SIERRA GEOTECHNICAL SERVICES INC.

Subject: **RESPONSE TO PEER REVIEW**
Phase 2 of Tentative Tract 37-46
White Mountain Estates Subdivision
Chalfant Valley, Mono County, California

Reference: Review Of Earthquake Fault Zone Hazard Evaluation Reports
Tract 37-16 And Phase 2 of Tentative Tract Map No. 37-46
White Mountain Estates Subdivision
Chalfant Valley, Mono County, California
Prepared by AMEC Earth & Environmental dated January 12, 2006

PROJECT: GEOLOGIC LOG OF DEEPEMED TRENCH T-5 PHASE 2 OF WHITE MOUNTAIN ESTATES SUBDIVISION				
HORIZ. SCALE: 1"=5'		VERT. SCALE: 1"=5'	DATE: 3/29/2006	
DRAWING 3.30559_DEEP TRENCHES.DWG		LOGGED BY: HDD/RWS		DRAFTED BY: HDD/RWS
JOB NO: 3.30559		TITLE: SHEET 6 OF 7

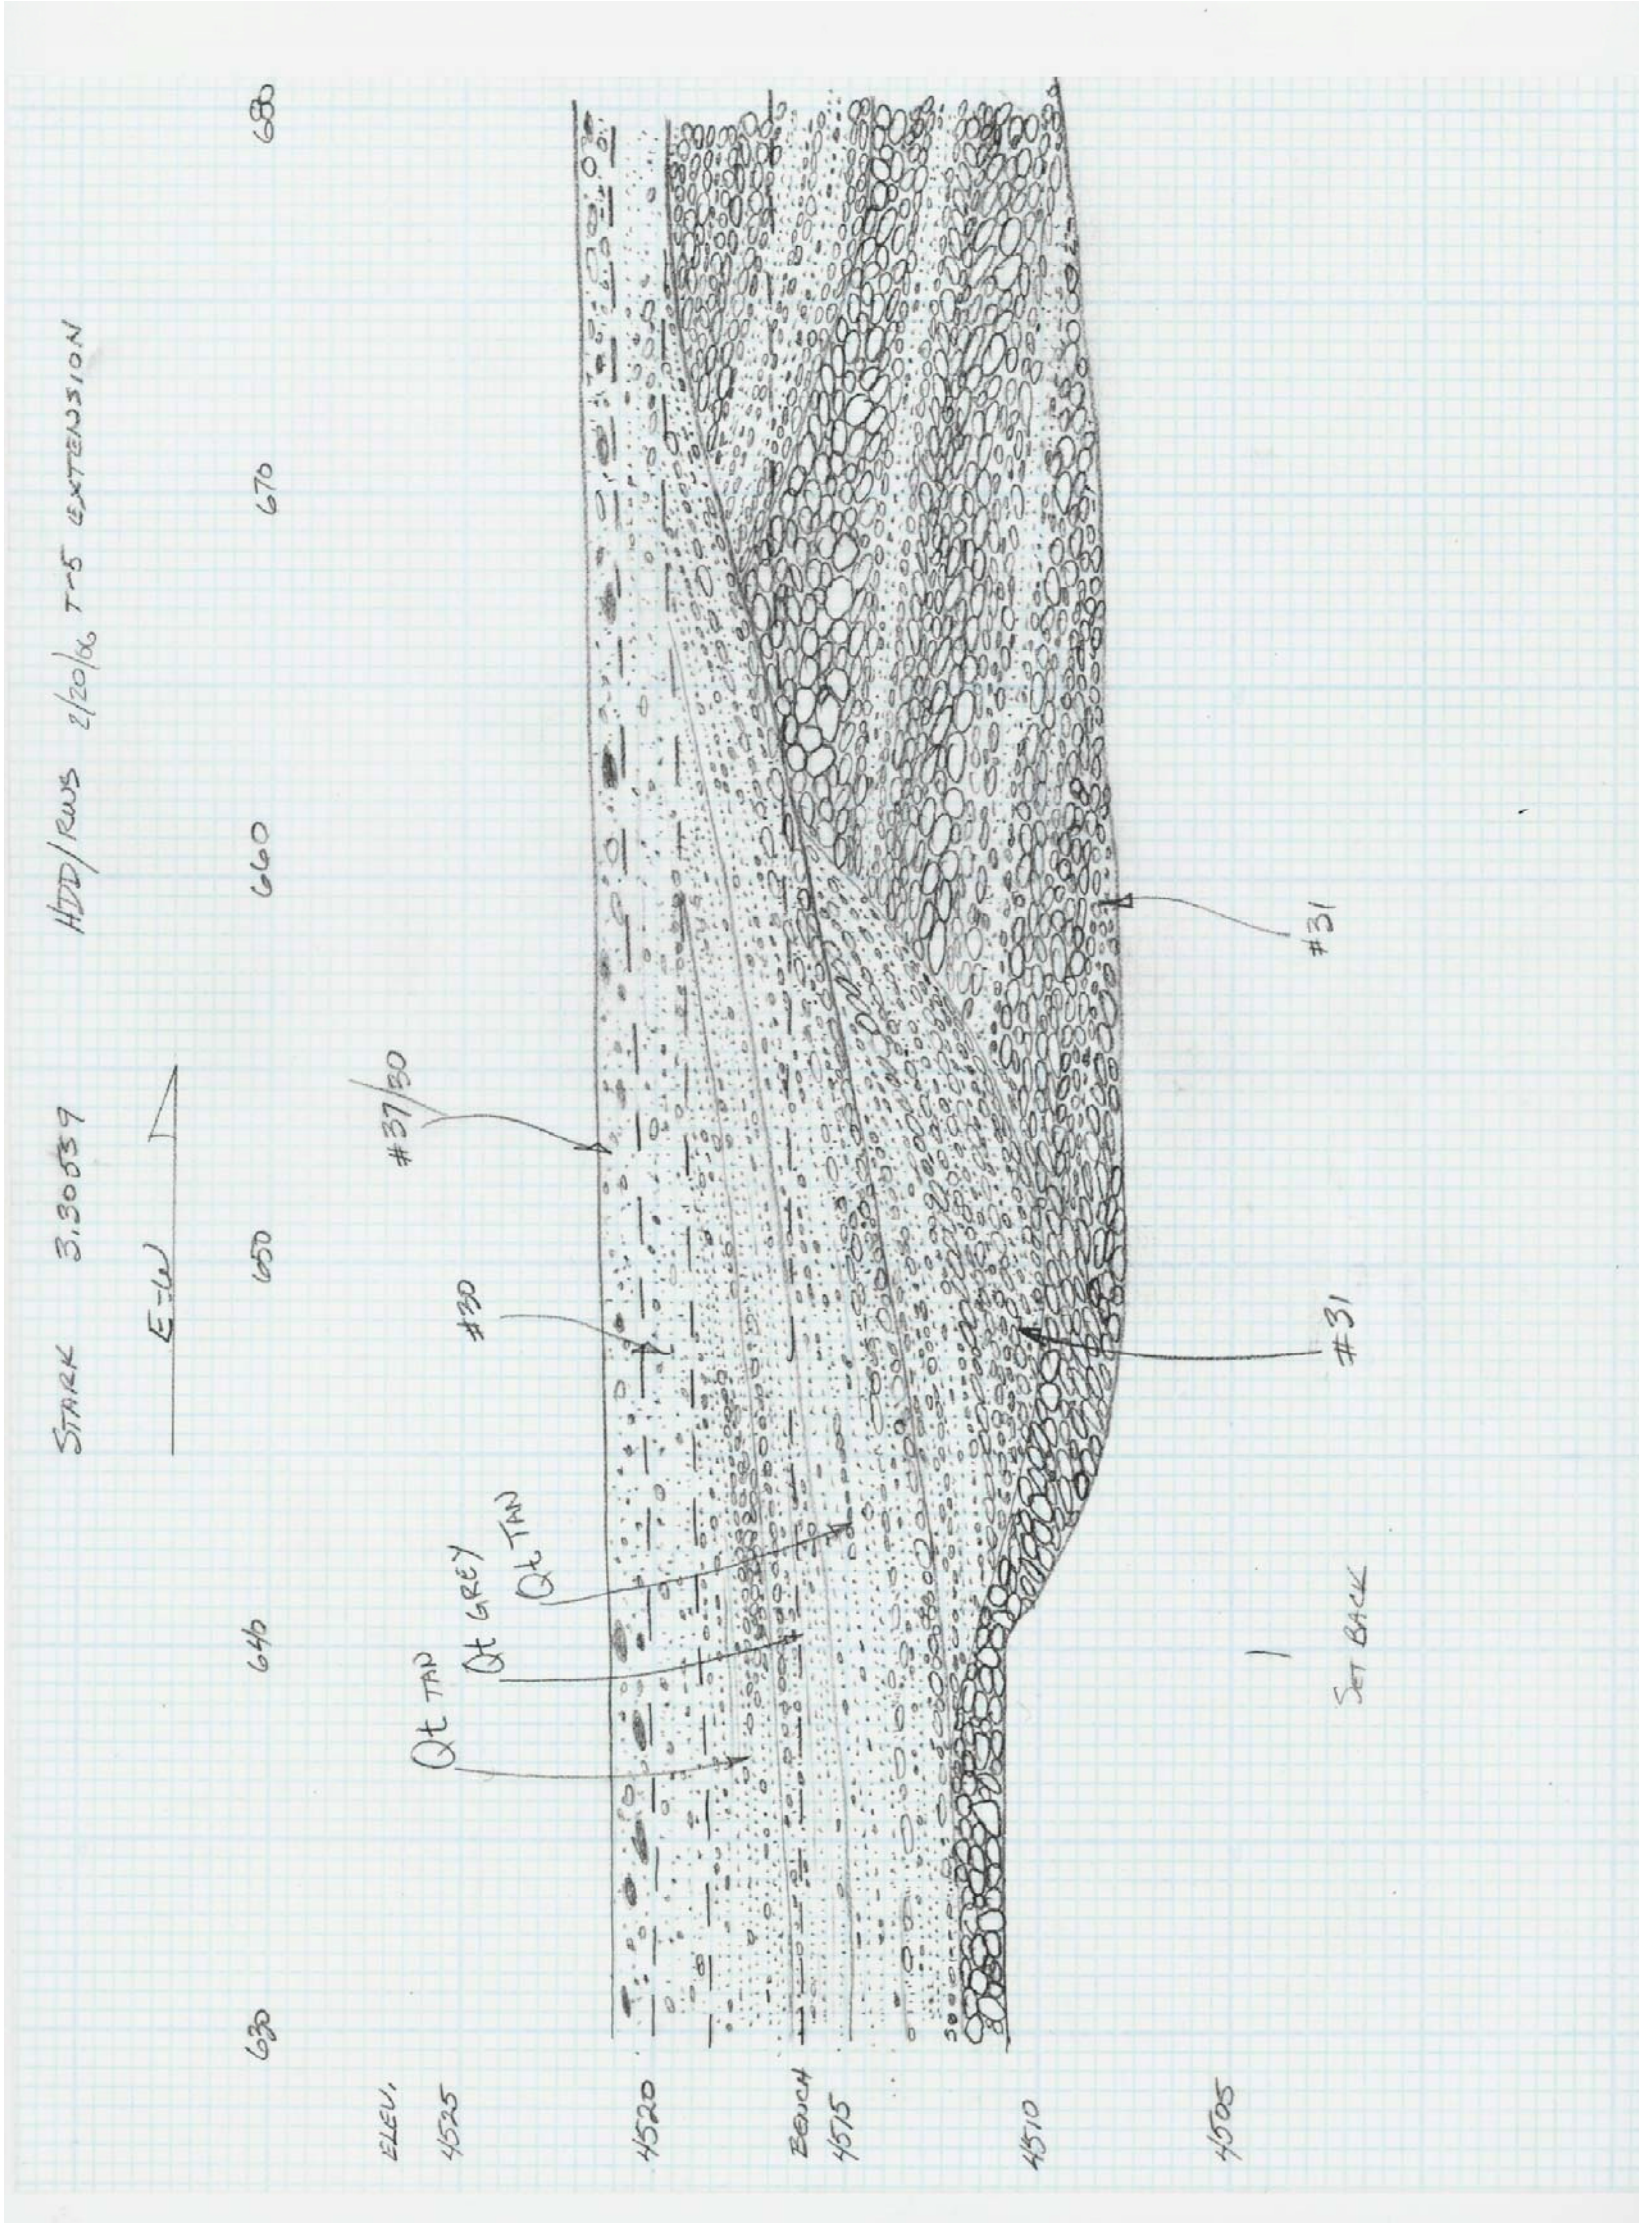
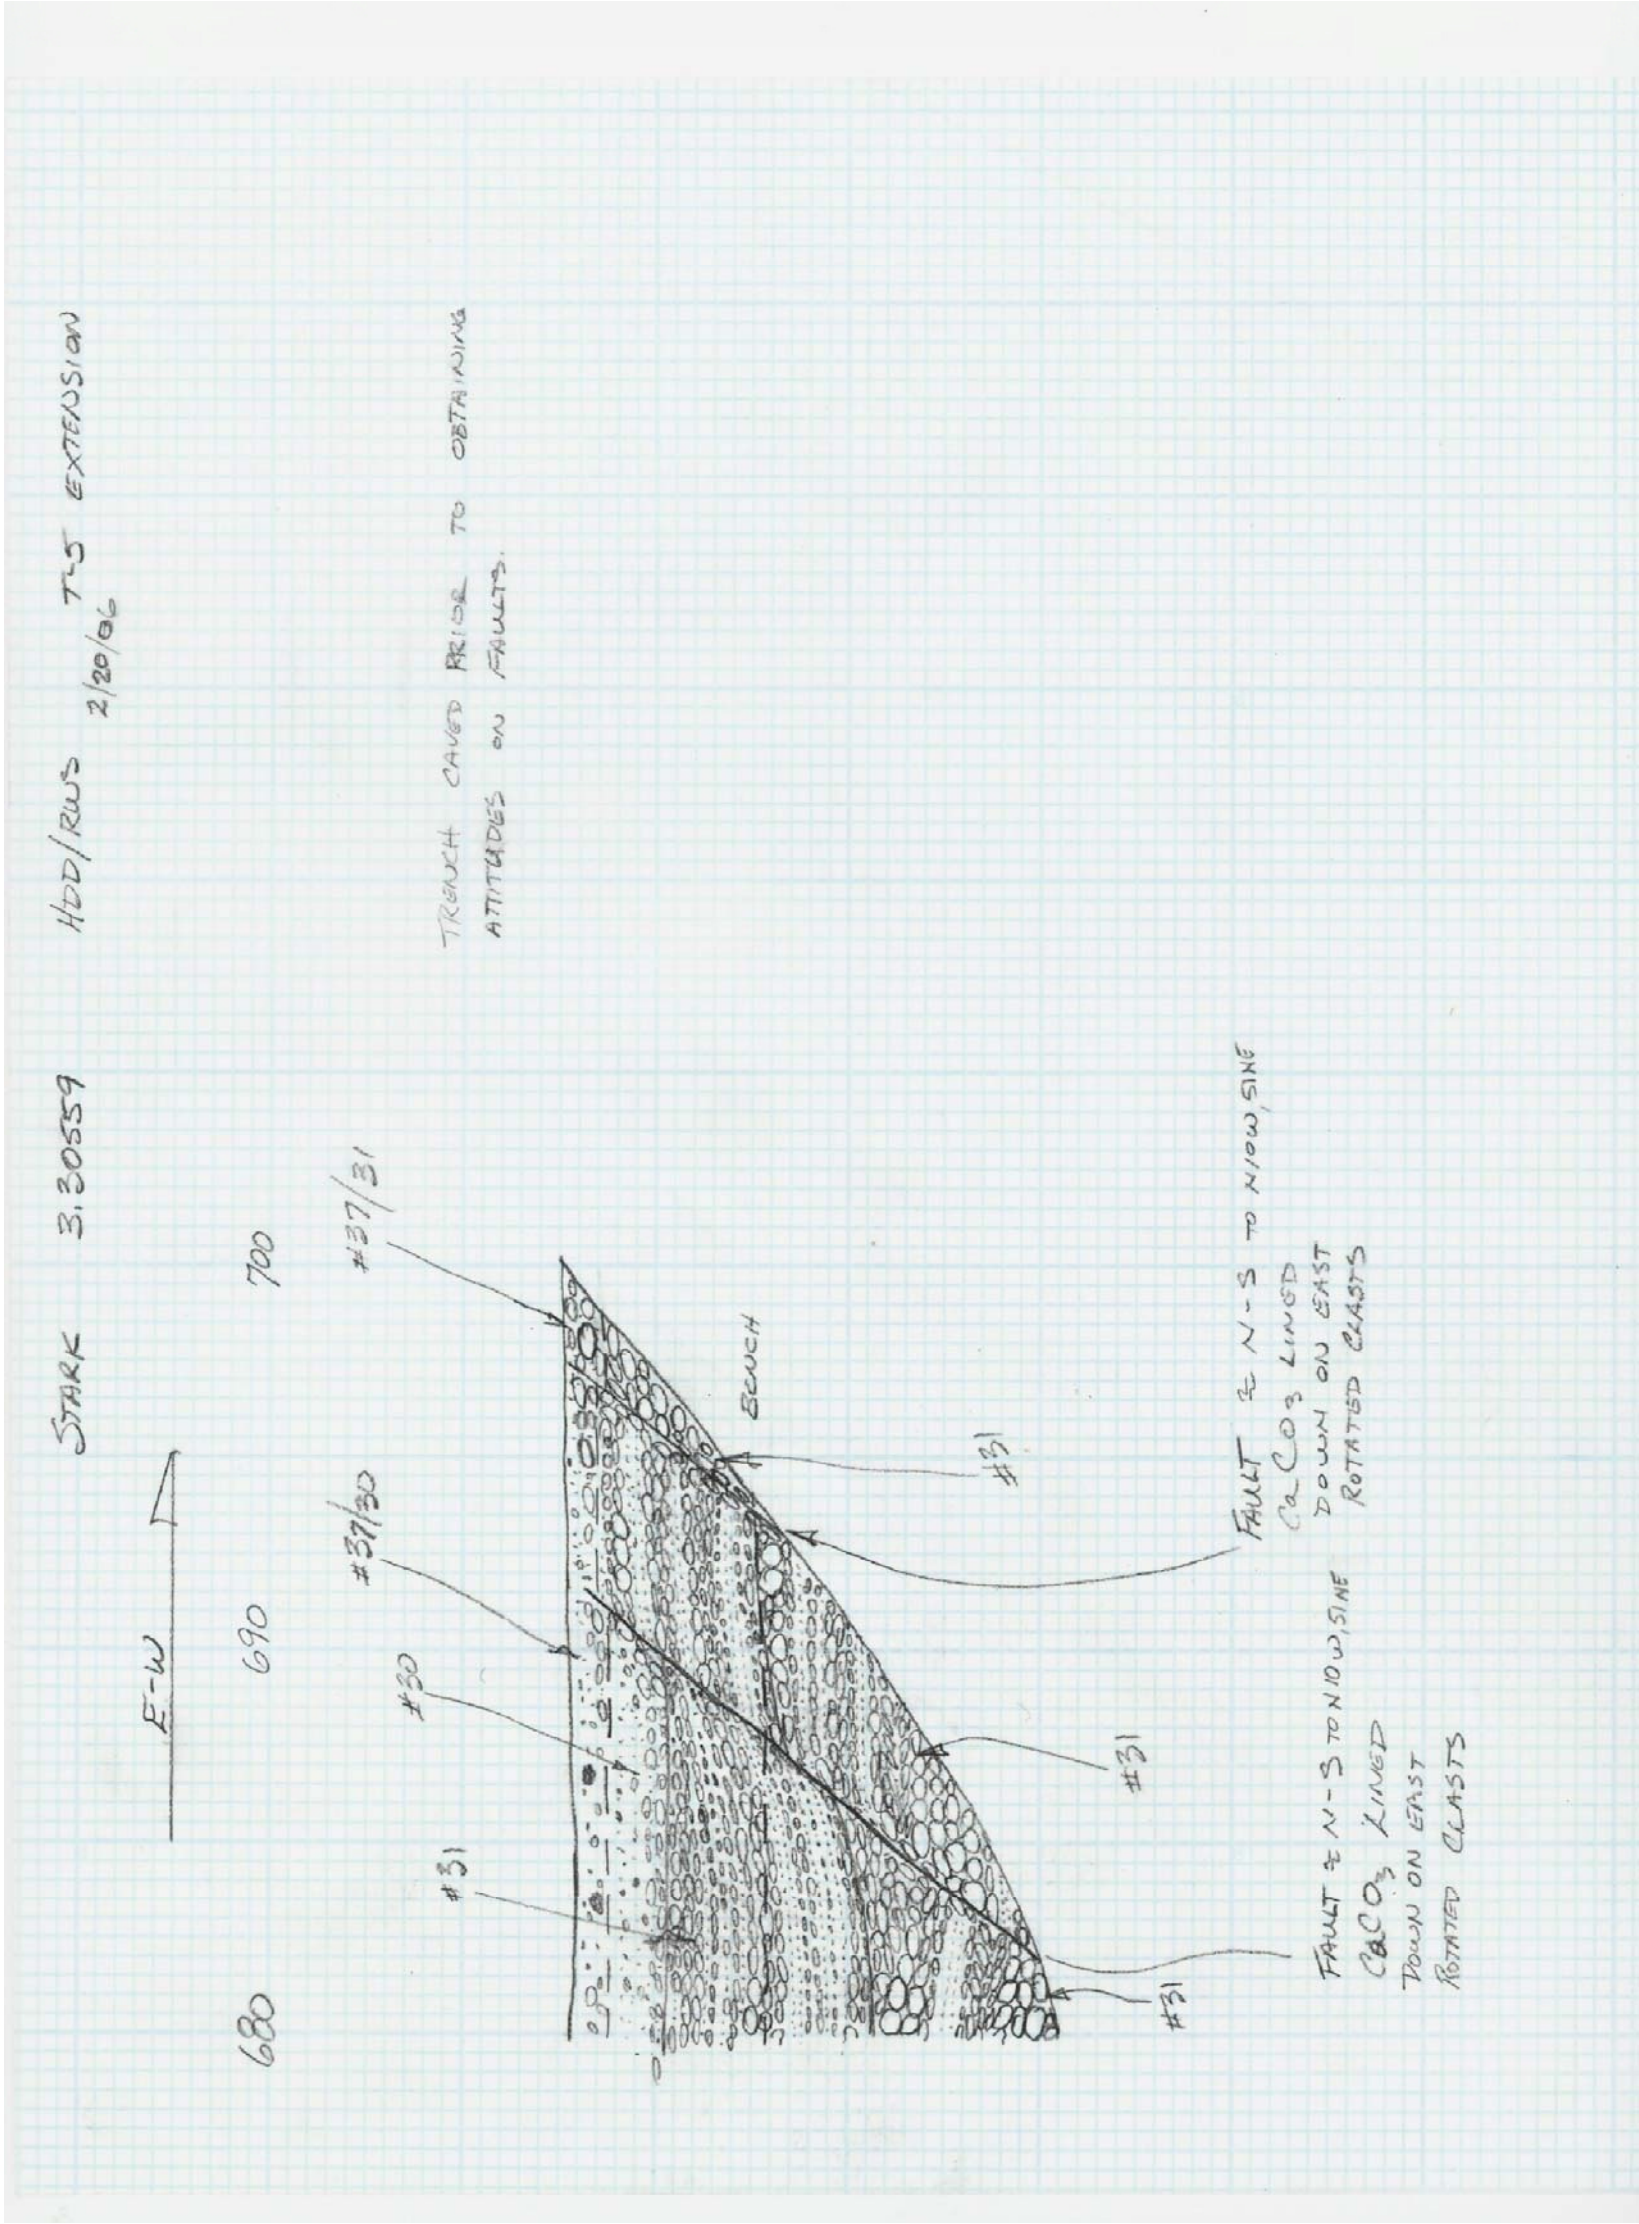
The designated habitable areas within Lot 45 are based on the fault related features and their structural orientations as observed and subsequently depicted in the logs of Trenches T-5 and T-6. The geomorphic features mapped within Lot 45 have been designated as Qfy (2), Qfi (3/4) and Qfo (6) having respective ages varying from Holocene to Middle-Early Pleistocene as previously determined by Bruce Schell. The alluvial sediments exposed in the fault Trench T-5 and T-6 are described by SGSI as being recent to late Pleistocene in age. The designated habitable areas within Lot 45 are depicted as two triangular shaped areas that are approximately 140 [feet] wide at their widest point. The easterly most area is situated on uplifted and eroded terrain associated with the Qfo (6) alluvial terrace surface. The proposed habitable area to the west is situated on recent alluvial deposits principally within an active drainage course.

The easterly 340 [feet] of Trench T-5 is situated within terrain that has been mapped as Qfo (6). A significant portion of these alluvial deposits appear to have been cut by active faults. The only portion that appears to have been unaffected is the roughly 35 [foot] wide section between Stations 2+88 and 3+23 that is inclined at a gradient of approximately 29 percent. This area may (sic) not be large enough to be considered buildable particularly when considering its narrow shape and the steepness of the existing ground surface.

The westerly portion of Trench T-5 from Station 3+40 to 5+26 is largely underlain by recent alluvial deposits. The contact at the base of the Holocene alluvial sediments has not been exposed over most of this portion of Trench T-5 and as such a definitive statement regarding the active faulting cannot be made by the project consultant. Based on these conditions it is recommended that the proposed habitable [area] associated with the westerly portion of Trench T-5 not be accepted without deepening of the trench to expose the full section of Holocene alluvial fan deposits, from the contact with the underlying Pleistocene alluvium to the ground surface, that are unaffected by fault features. The project consultant should also consider the buildability of this area considering the potential for flood related issues as this area is largely situated in an active drainage course.

Response: In conformance with the recommendation provided in the comment above, Trench T-5 was re-trenched to expose the full section of the Holocene alluvial fan from the ground surface down to its contact with the underlying older Pleistocene alluvium. Deepened Trench T-5 was also extended west for an additional 155 feet to Station 7+00. Based upon our observations and logging of the deepened exposure, active faulting was not observed in the older deposits between Station 3+40 through 5+26. This find is not consistent with the faults found in Trench T-6 to the south. An effort was made to crosscut the faults projecting northward from Trench T-6 in order to account for the lack of faulting observed in deepened Trench T-5, but this could not be accomplished. Instead, both the geologic log of Trench T-6 and the geomorphic expression of the topography surrounding Trench T-6 were re-interpreted to be a landslide, which accounts for the lack of faulting in deepened Trench T-5. Landslide features are observed in Trench T-6, and they include a buried head scarp at Station 2+90, a backfilled graben between Stations 2+90 and 3+85, back-rotated landslide blocks between Stations 3+85 and 5+10, and basal slide planes near the landslide toe between Stations 5+10 and 5+38. Geomorphic landslide

features are also observed in the topography that surround Trench T-6, and they include a steepened slope at the landslide head, two re-entrant gullies ascending up to the landslide head from the drainage on the north and from the drainage on the south, and “over-steepened” slopes on both hills that ascend from where these drainages converge, which is the same location where the landslide came to rest. The landslide has been somewhat modified and “melted” by cumulative erosion over time, but the geomorphic features are still substantially preserved.

Active faulting was observed at the westernmost extent of deepened Trench T-5 from Station 6+80 to 7+00. This observation is a better fit for Significant Fault No. 3, which projects north from the westernmost extent of Trench T-6. It is interpreted that this east-dipping fault provided the mechanism by which movement occurred along the toe for this landslide. Therefore, based on the new data observed in deepened Trench T-5 our new interpretation for the landslide in Trench T-6, and the potential for flood related hazards from the drainage, the proposed habitable areas on Lot 45 have been revised, and they are delineated on the Revised Geologic Map.
